**DESIGN & CONSTRUCTION MANUAL  
DESIGN CRITERIA MODIFICATION REQUEST**

PROJECT NAME: Bailey Farms

## Waiver Request Report

BAILEY FARMS  
 WAIVER EXHIBIT

WAIVER EXHIBIT

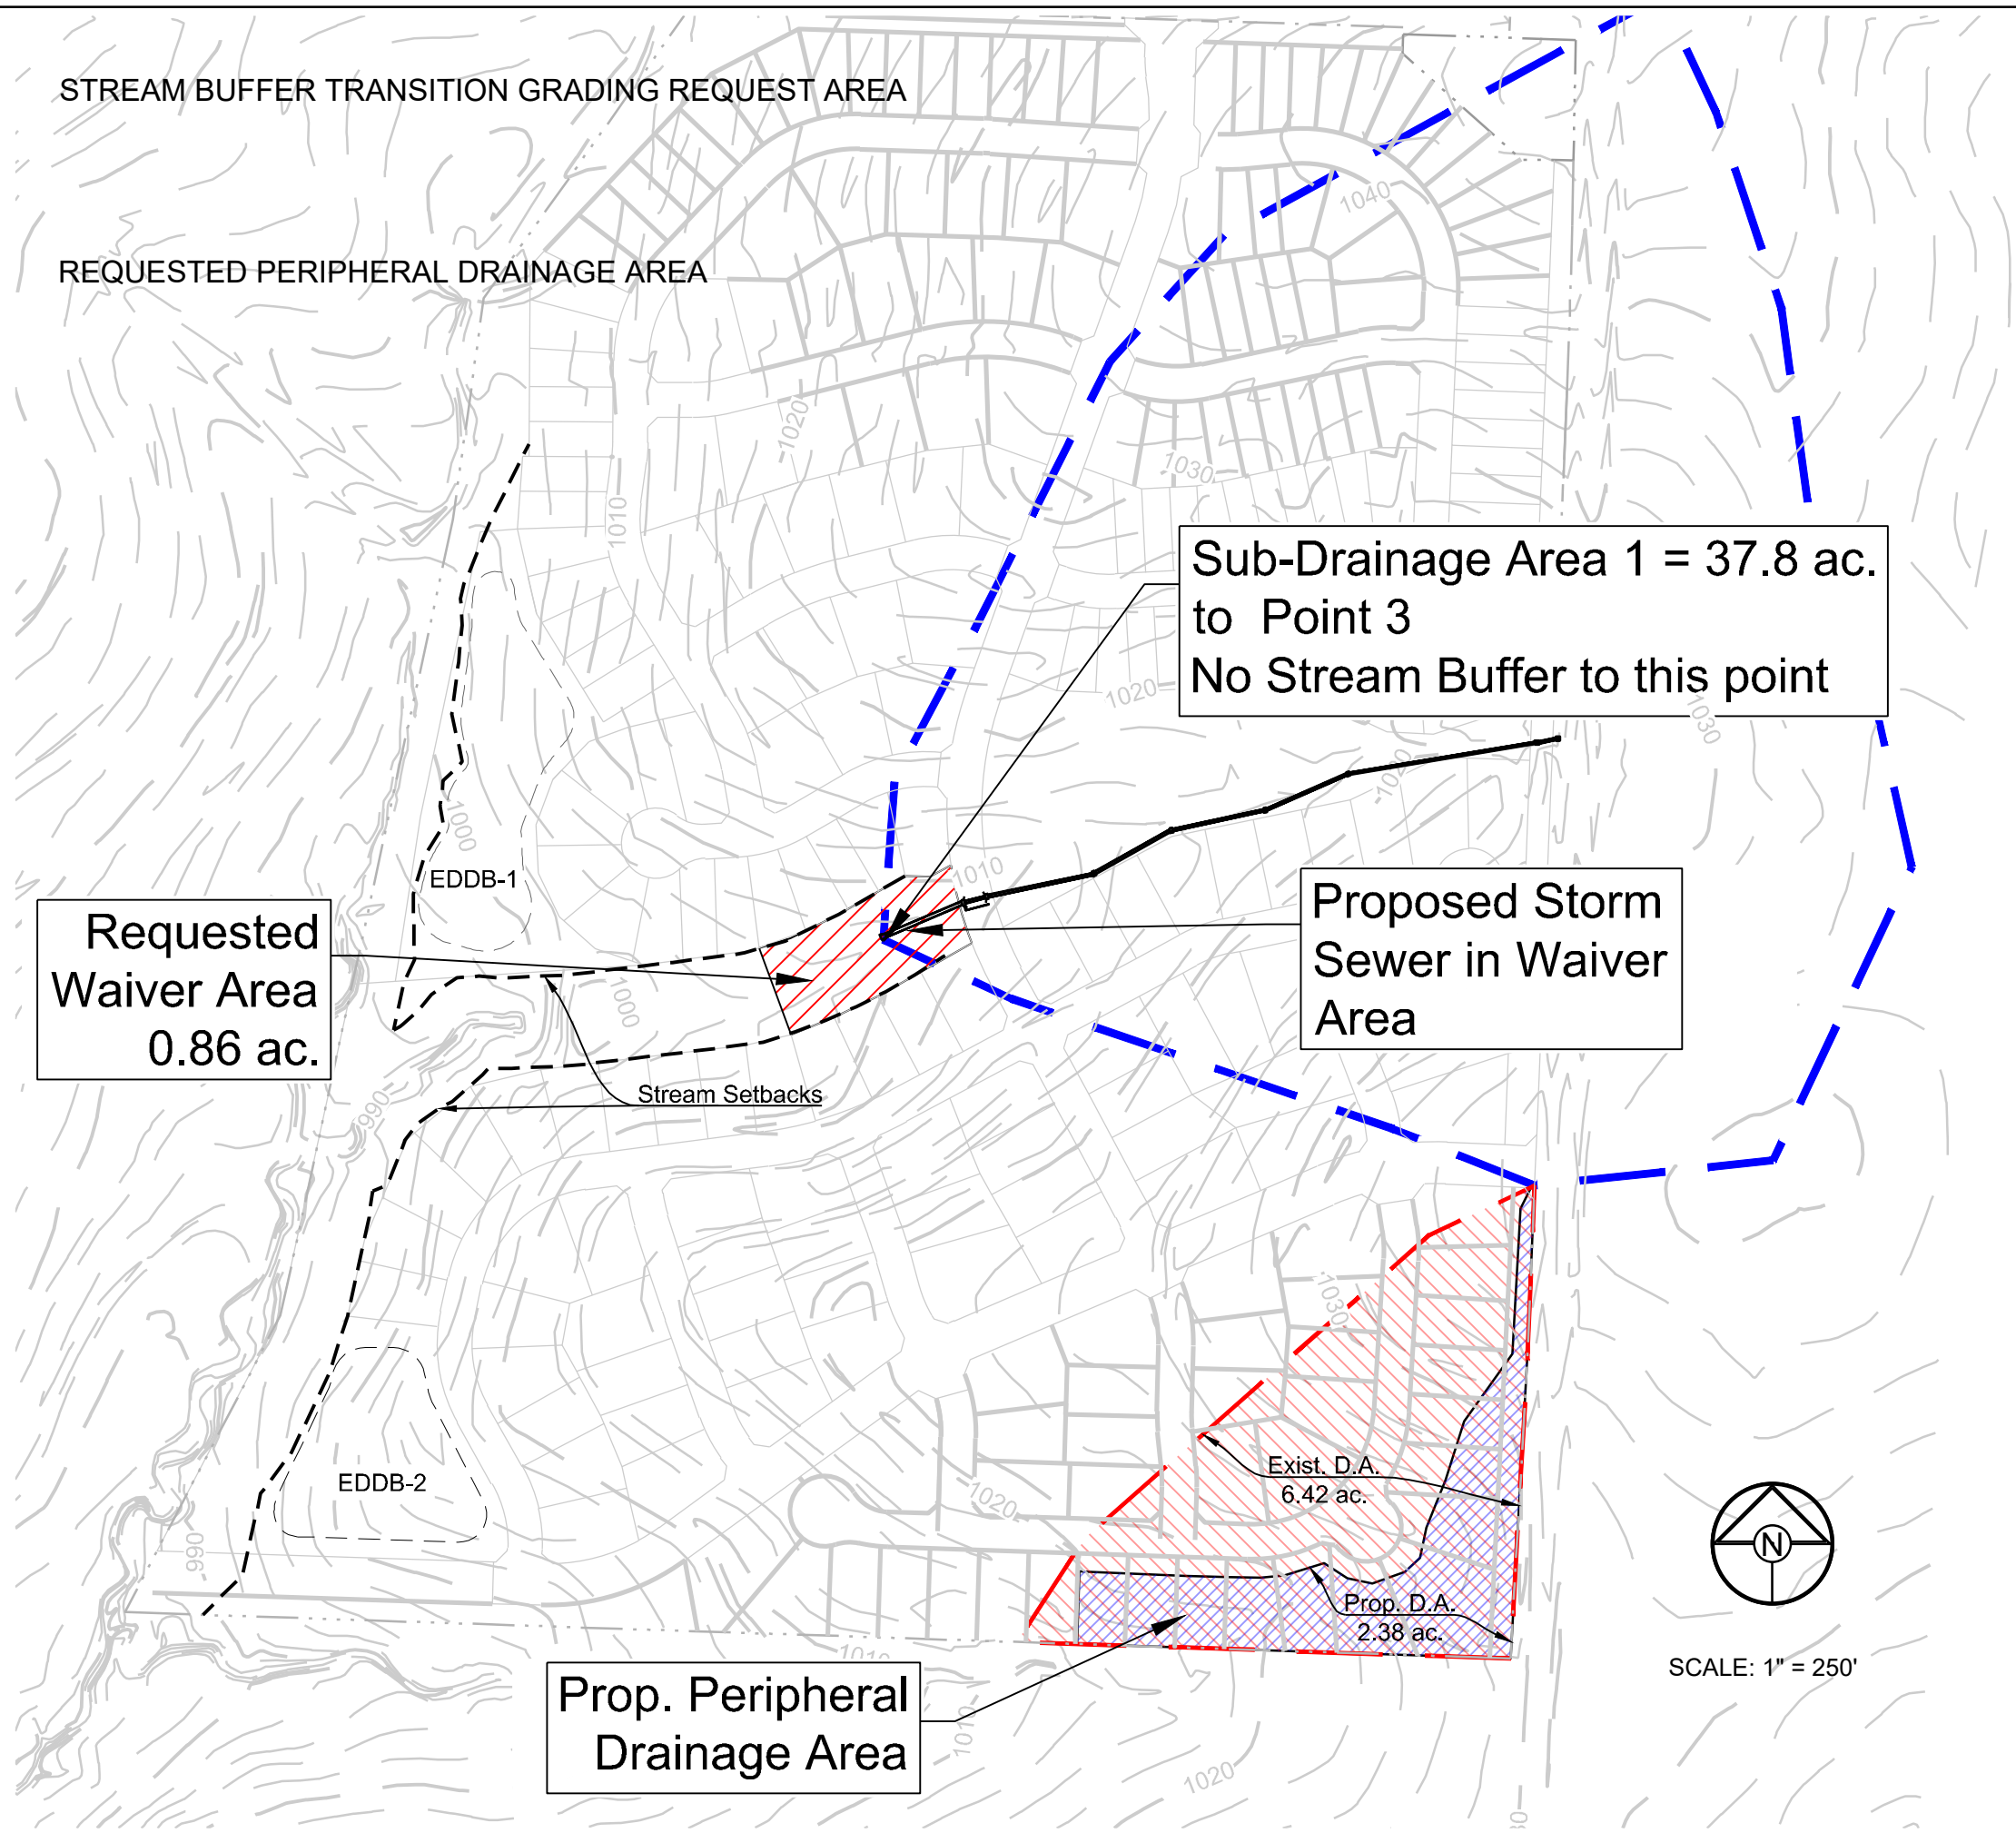
APWA 5600 section 5608.4.C.1 Comprehensive Detention. We are requesting that a waiver be approved based on site limitations and previous conversations with city staff regarding design requirements in the southern portion of the site. Given that we are decreasing the tributary area from 6.42 ac. to 2.38 ac., approximately 60% reduction in area and the site limitations to add an additional detention facility, we are requesting this area be considered a peripheral drainage area.

The project also includes a request for modification of APWA 5605.3 – Stream Preservation and Buffer Zones to allow transition grading and storm sewer installation in the stream setback. The grading will occur in areas that have no trees and are currently being farmed. The area proposed for the modification is currently disturbed by farming, therefore, no natural vegetation should be in the area to preserve. The grading will not affect the natural condition of the stream and will allow sufficient space to allow the existing stream to flow naturally. Any proposed construction activities with this development will not interfere with the natural meandering of this stream. In addition, the proposed constuction will also not cause any channel constrictions within the flow level of the 100-year storm

In accordance with the Lee’s Summit Design and Construction Manual (DCM) Section 1002.A, I wish to apply for a modification to APWA 5600 Section 5608.4.C.1a Comprehensive Control requirements. We are requesting that the waiver be approved based on site limitations and previous conversations with City Staff regarding design requirements in the southern portion of the site. Given that we are decreasing the tributary area from 6.28 ac. to 2.38 ac., a greater than 60% reduction, and the site limitations to add an additional detention facility, we are requesting that this southern portion of the development be considered a peripheral drainage area. Also note, that run-off from the streets will be captured in the storm system and routed to the proposed detention basin located in the southwest corner of the site. Only the houses and backyards will drain to the south.

The project also includes a request for modification to APWA 5605.3 – Stream Preservation and Buffer Zones to allow transition grading in the stream setback. The drainage area to this proposed grading area is close to 40 acres, requiring a 60’ buffer from that point downstream. The proposed grading and storm sewer installation will occur in areas that have no trees and is currently farmed, therefore, it is anticipated, that no natural vegetation will be disturbed. The grading will not affect the natural condition of the stream and will allow sufficient space to allow the existing stream to flow naturally. Any proposed construction activities with this development will not interfere with the natural meandering of this stream. In addition, the proposed constuction will also not cause any channel constrictions within the flow level of the 100-year storm. An exhibit for the area described above is included with this waiver request.

STREAM BUFFER TRANSITION GRADING REQUEST AREA

REQUESTED PERIPHERAL DRAINAGE AREA

Requested Waiver Area  
0.86 ac.

Sub-Drainage Area 1 = 37.8 ac.  
to Point 3  
No Stream Buffer to this point

Proposed Storm Sewer in Waiver Area
